Chief Executive's Report on the Submissions and Observations Received on the Draft Wexford County Development Plan 2021-2027

Section 2 – Volume 3 Bunclody Town Settlement Plan

Summary of Main Issues Raised and Chief Executive's Response

Figure B-5 Flood Zones Overlaid on Land Use Zoning Map

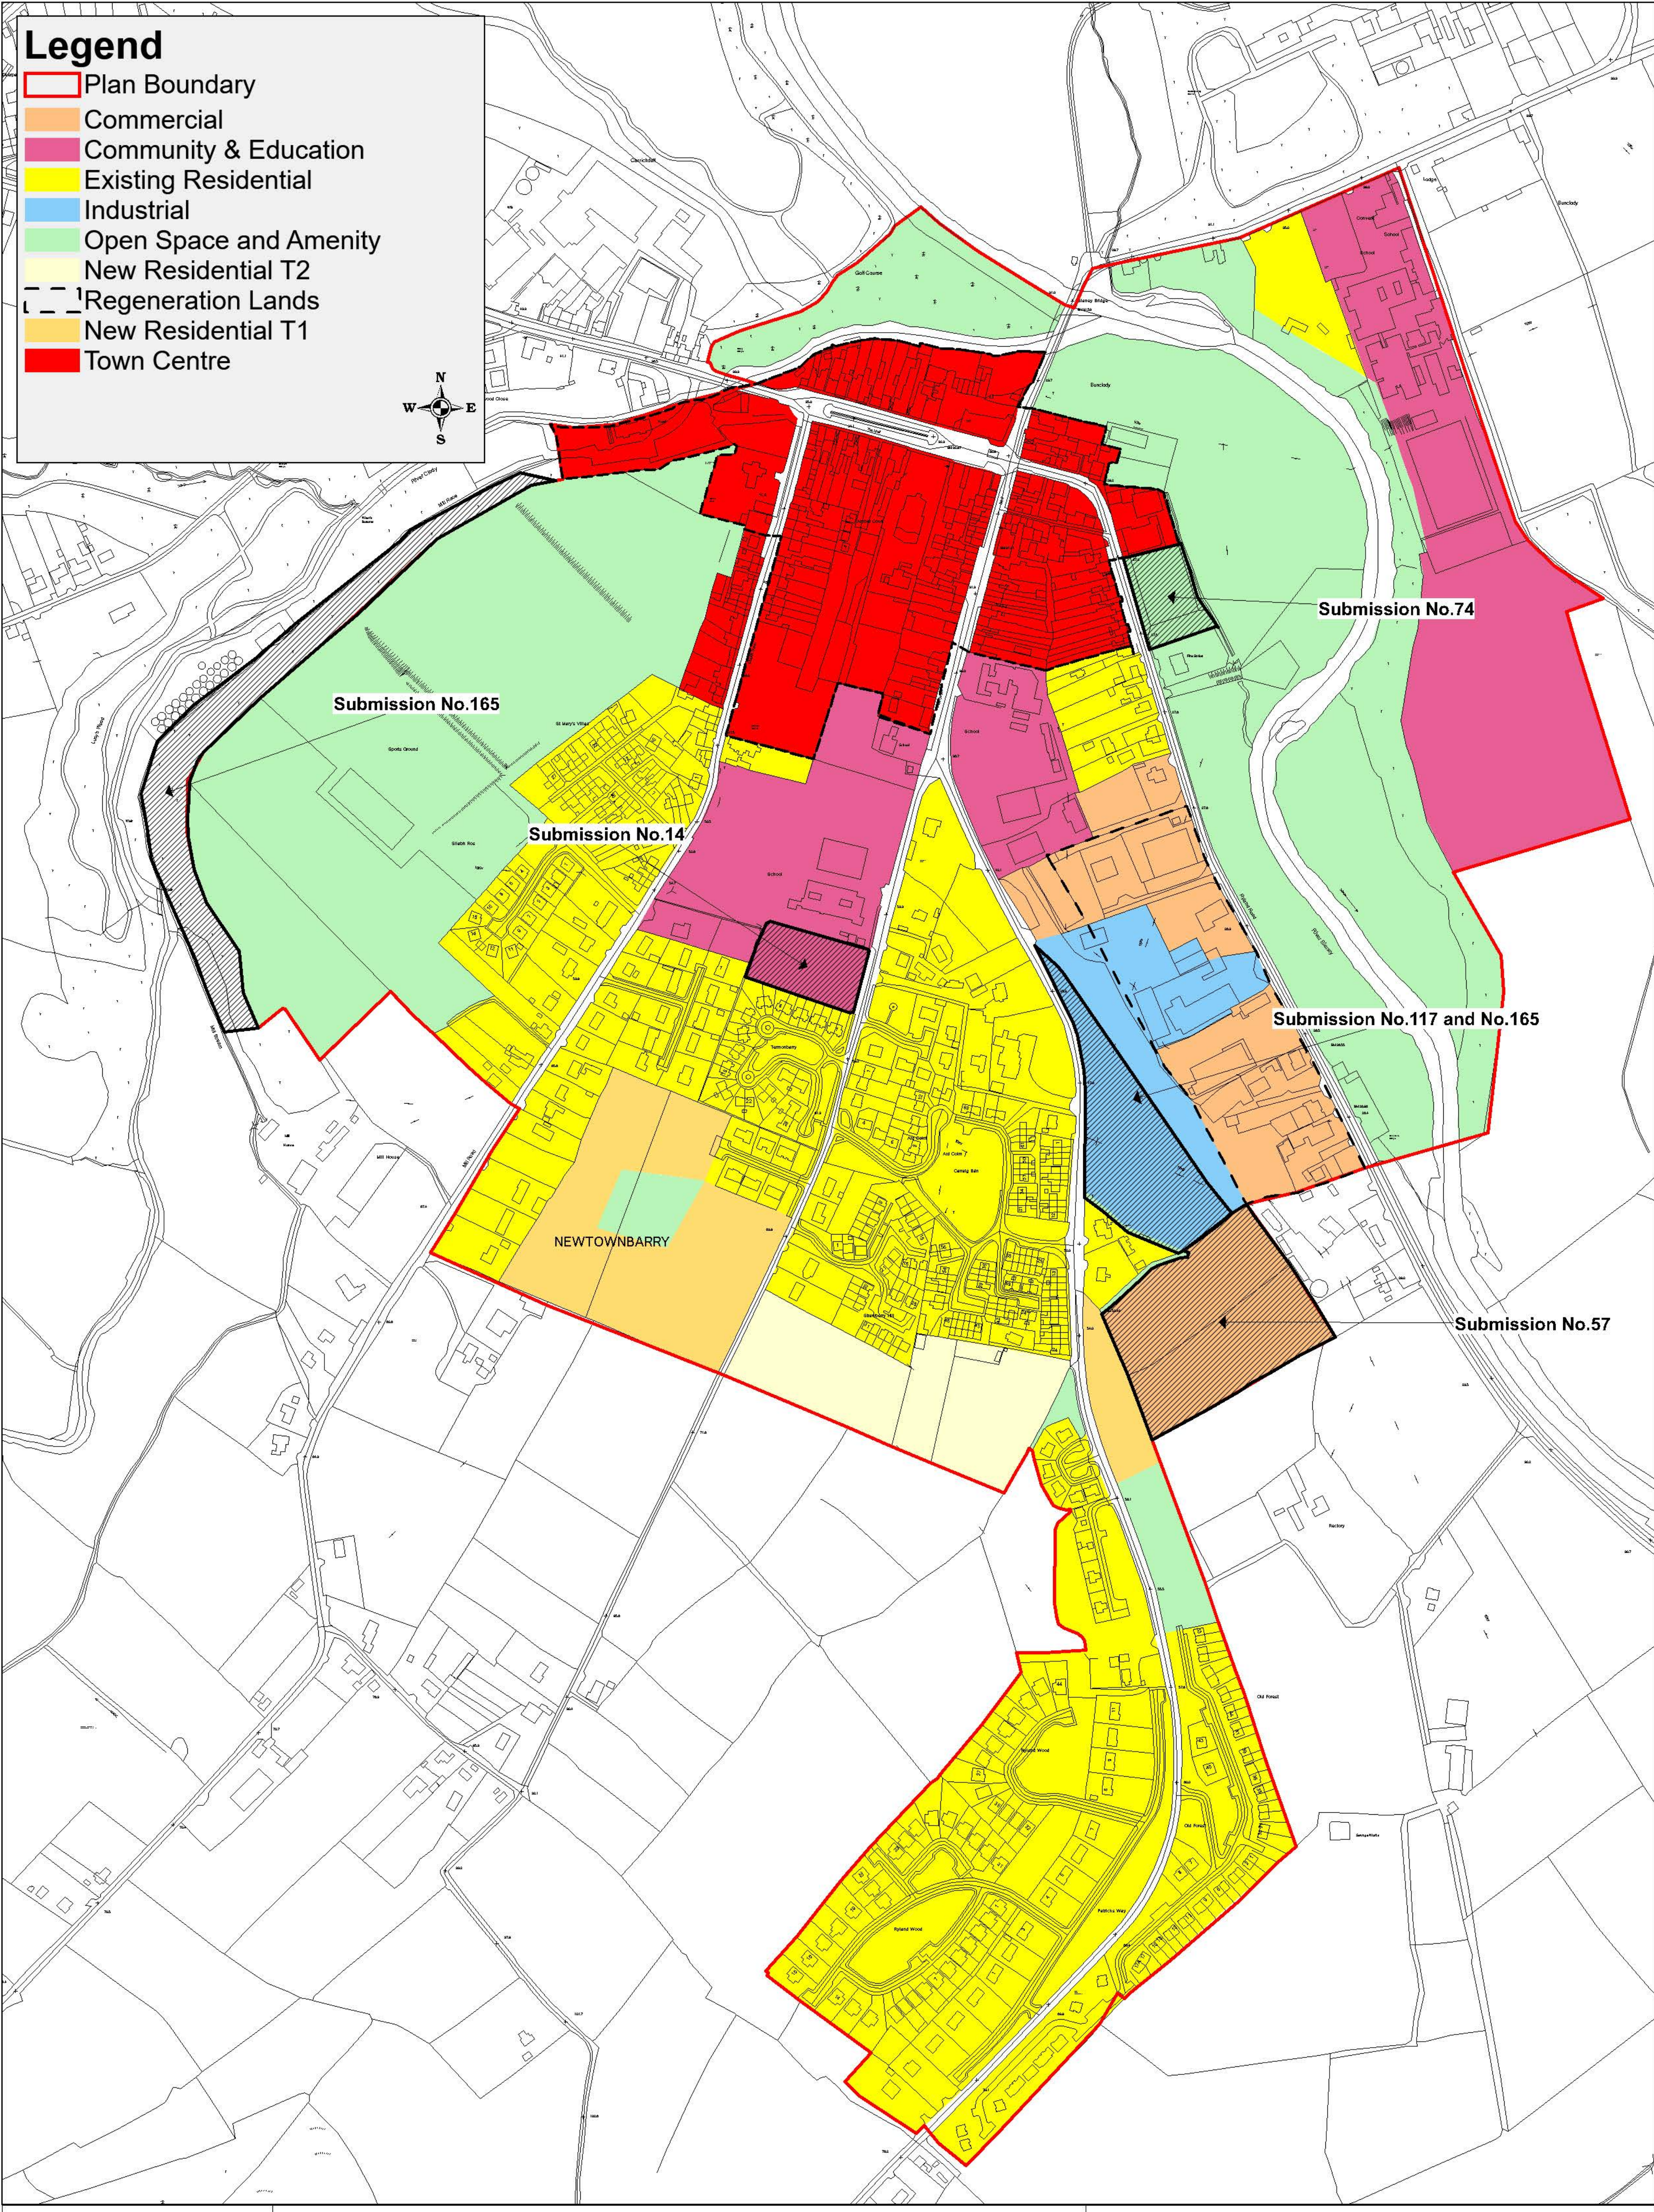
Replace Figure B-5 Flood Zone Overlaid on the Land Use Zoning on page 41 with a new version to reflect the proposed amendments to Map 1 Land Use Zoning. See amended Figure B.5 at the end of this section.

Title: Submissions on Land Use Zoning

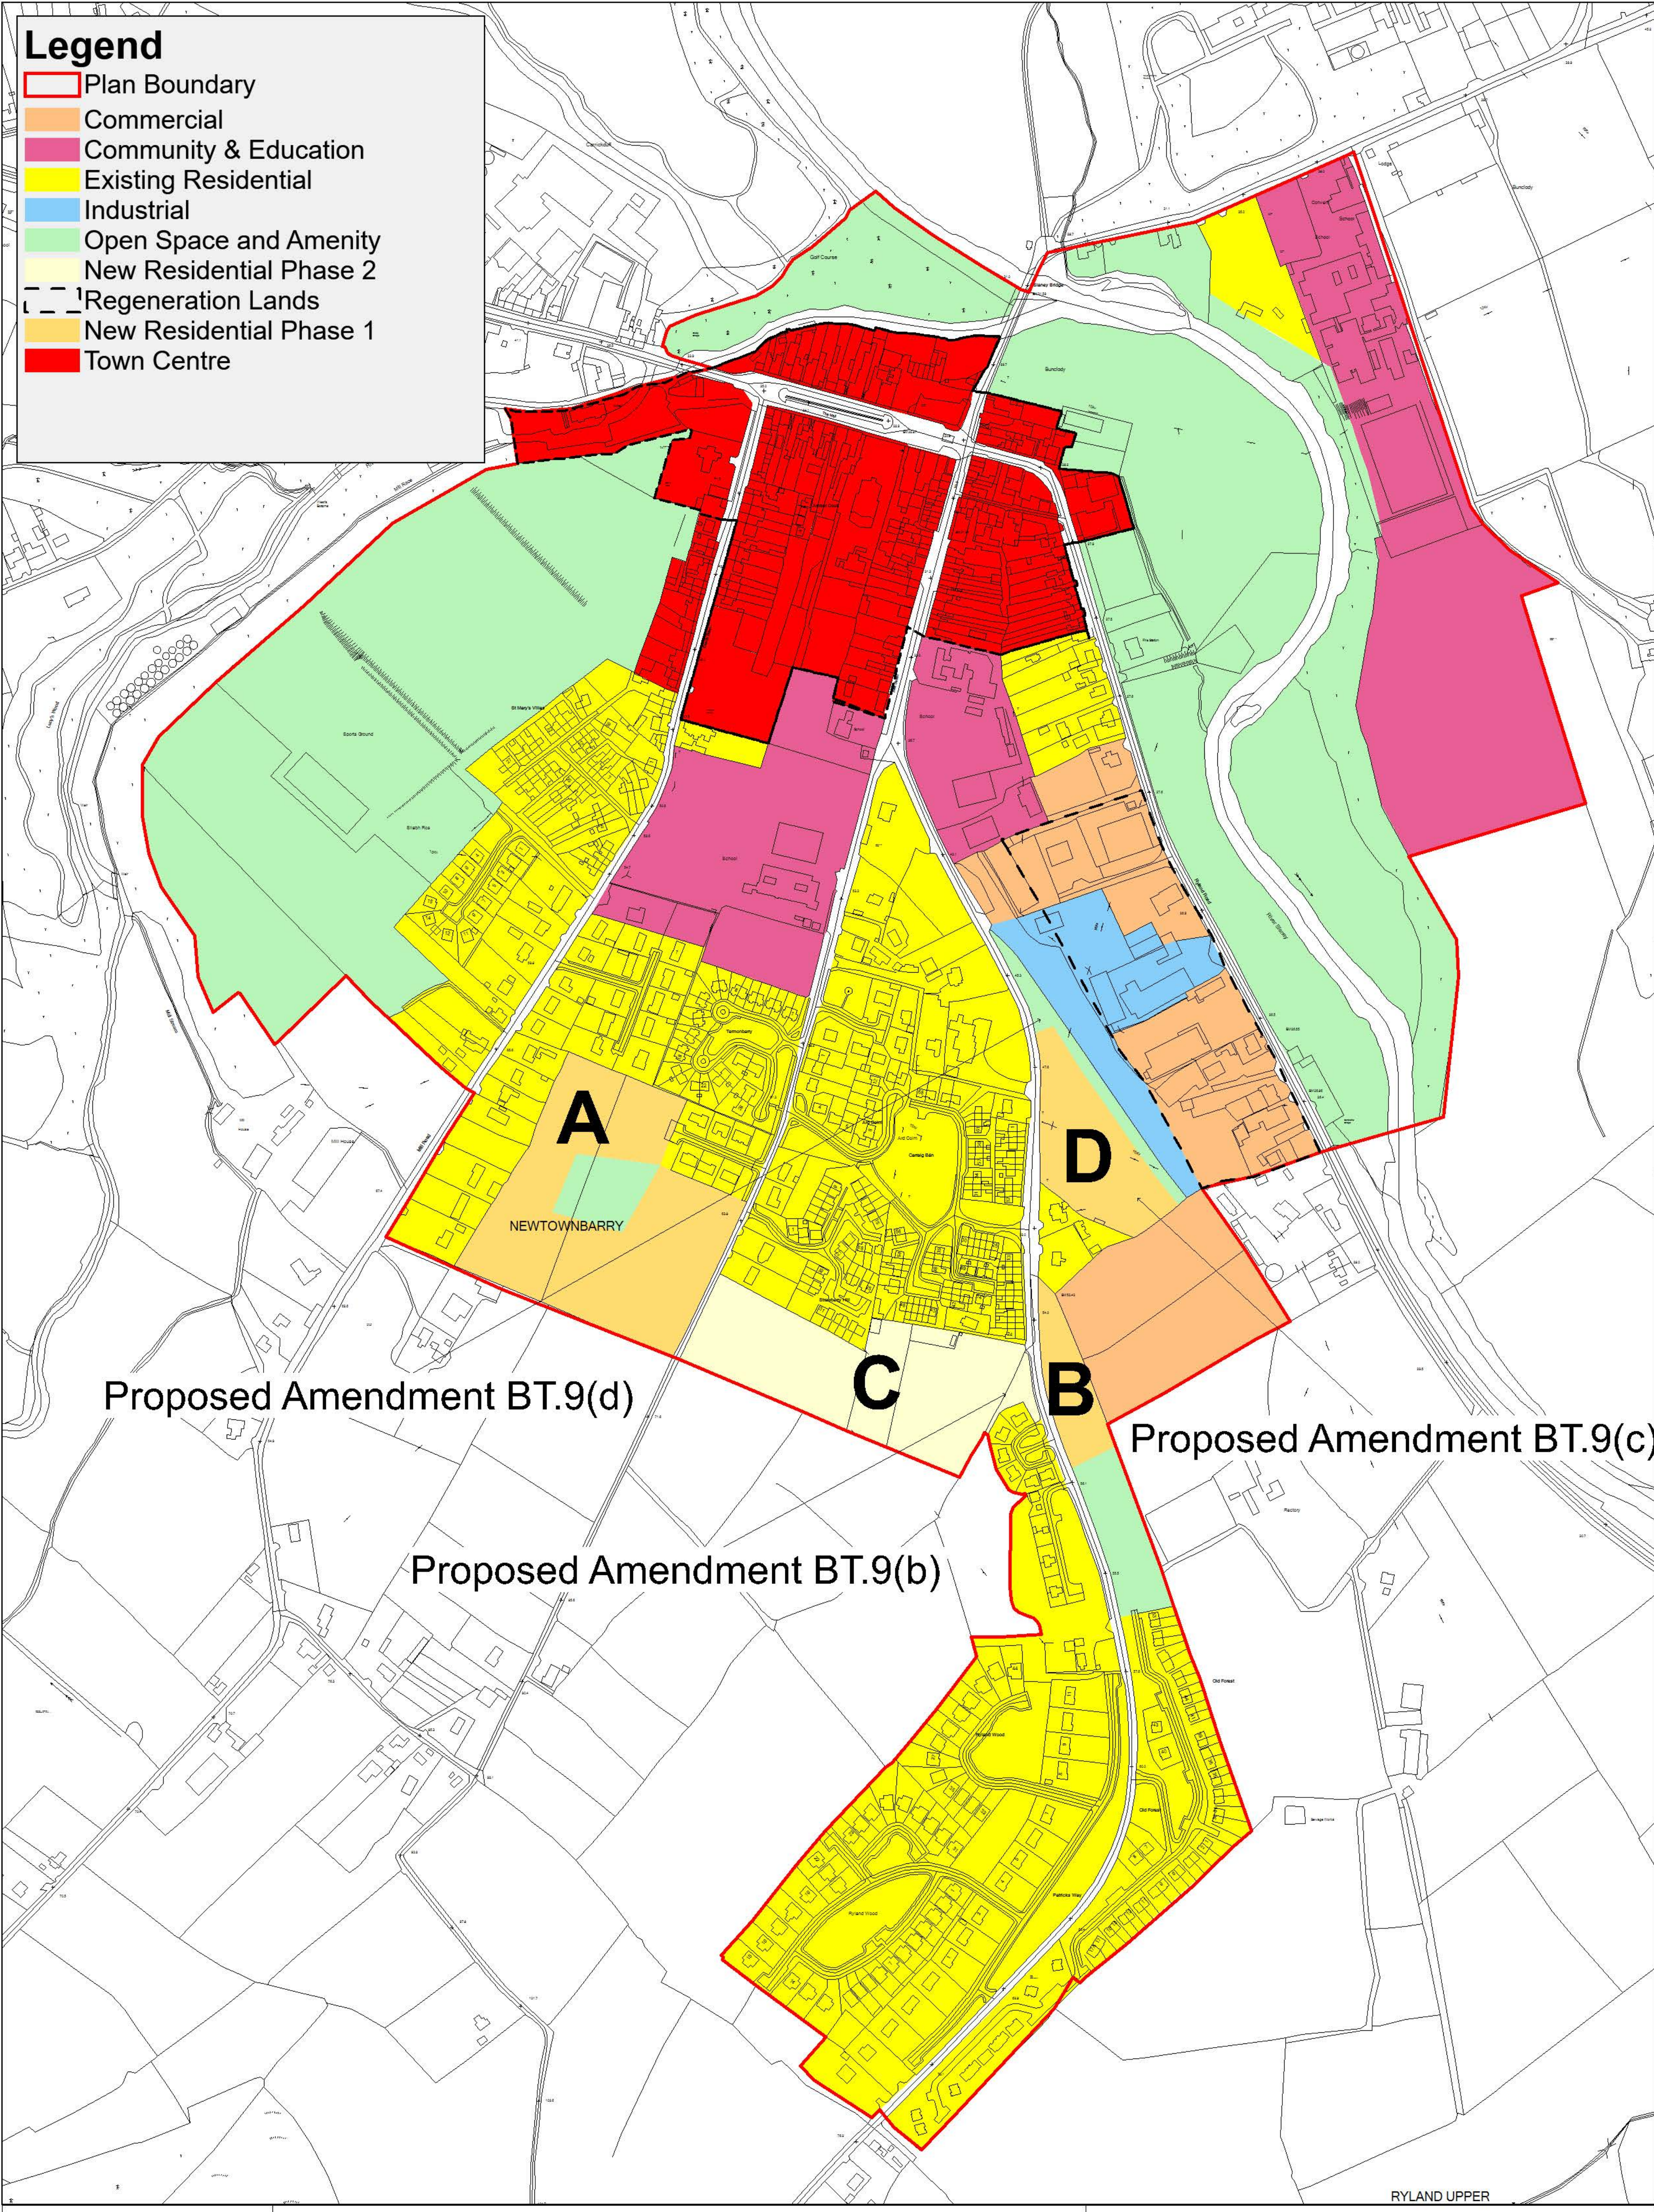
A number of submissions include requests for lands within the SP area to be rezoned. The following should be read in conjunction with Map B (A) which shows the location of the lands that are the subject of these zoning requests. The parcels are identified by their submission number e.g. No. 57, No. 117. Proposed amendments arising from consideration of these submissions are shown on Map 1 Land Use Zoning.
